RECORD OF DECISION

Tonawanda Forge Site
Operable Unit Number 01: Soil Contamination
State Superfund Project
Tonawanda, Erie County
Site No. 915274
March 2020

Prepared by
Division of Environmental Remediation
New York State Department of Environmental Conservation

NYSDEC TONAWANDA FORGE
TOWN OF TONAWANDA, NEW YORK
NON-AQUEOUS PHASE LIQUID
ANALYTICAL RESULTS

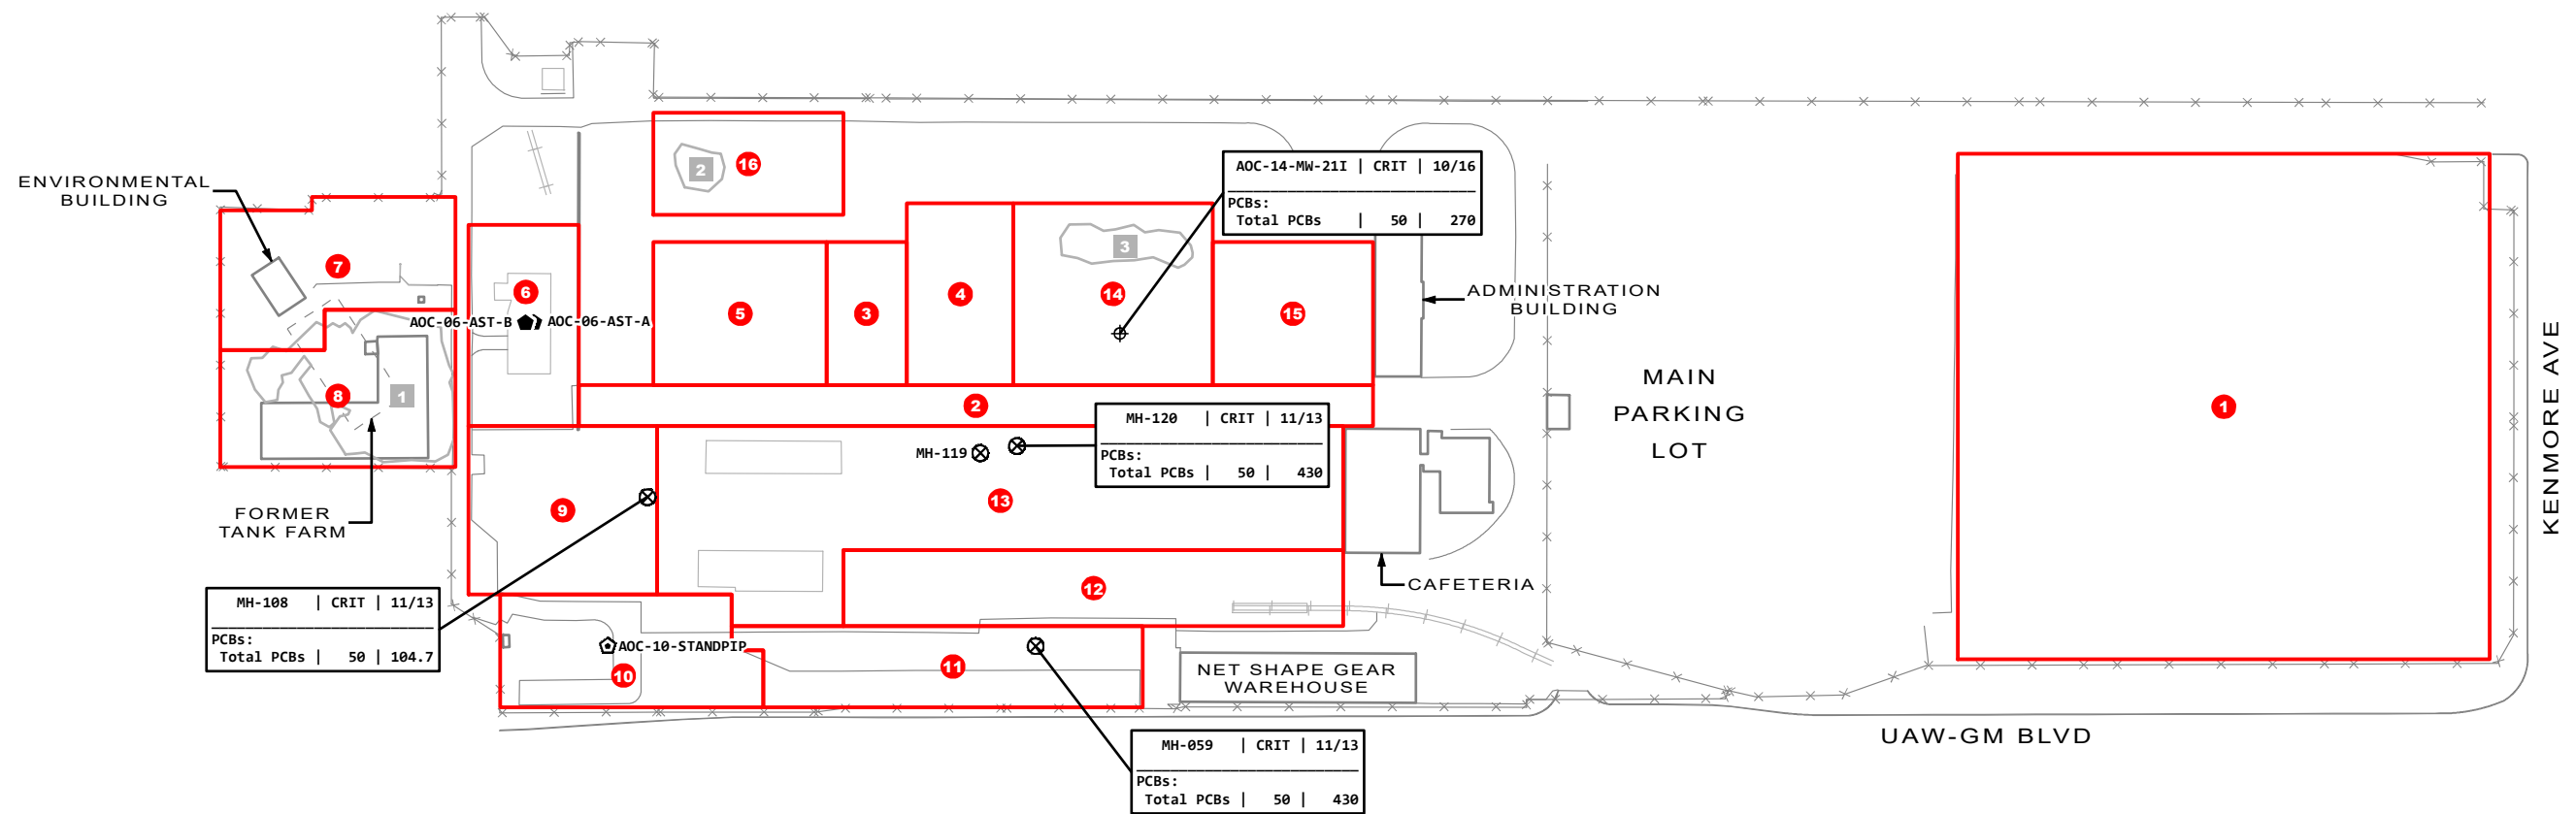
COMMENT 37: Exhibit A, Waste/Source Areas – LNAPL: Figure 3 shows MH-119 as having LNAPL present, but there is no indication of PCB content. Were no PCBs present?

RESPONSE 37: PCBs were detected in MH-119 but had a total concentration of 21 ppm, which is under the 50 ppm hazardous waste definition for PCBs. Only exceedances of hazardous waste limits are illustrated on Figure 3. Analytical results for LNAPL samples are included in Table 4-1 of the 2018 Remedial Investigation Report.

NYSDEC TONAWANDA FORGE
TOWN OF TONAWANDA, NEW YORK
CONCRETE AND ASPHALT CHIP, BRICK,
BULK SOLIDS, & WIPE SAMPLES
PCB ANALYTICAL RESULTS

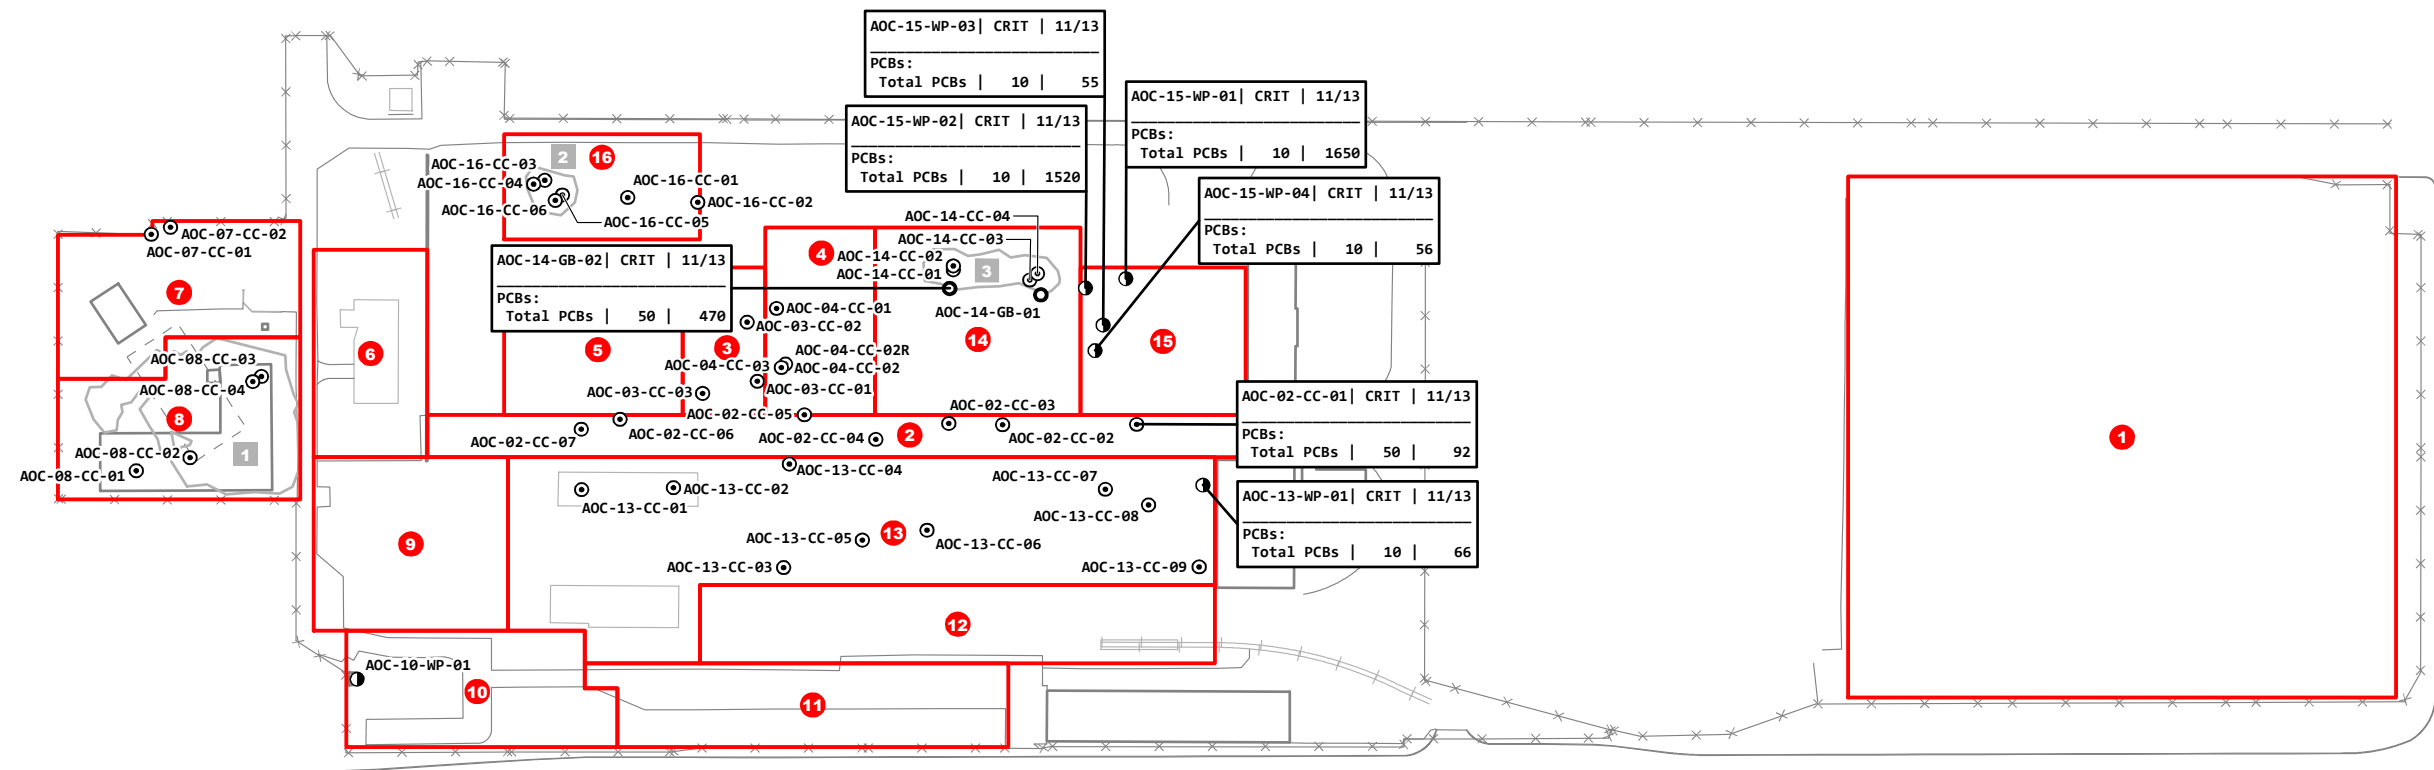
yet only one location is shown on Figure 4. Where was the other sample located?

RESPONSE 38: The brick chip sample is located in AOC-2 (AOC-02-CC-01) and the bulk sample is located in AOC-14 (AOC-14-GB-02). Figure 4 has been corrected to include the bulk sample location.
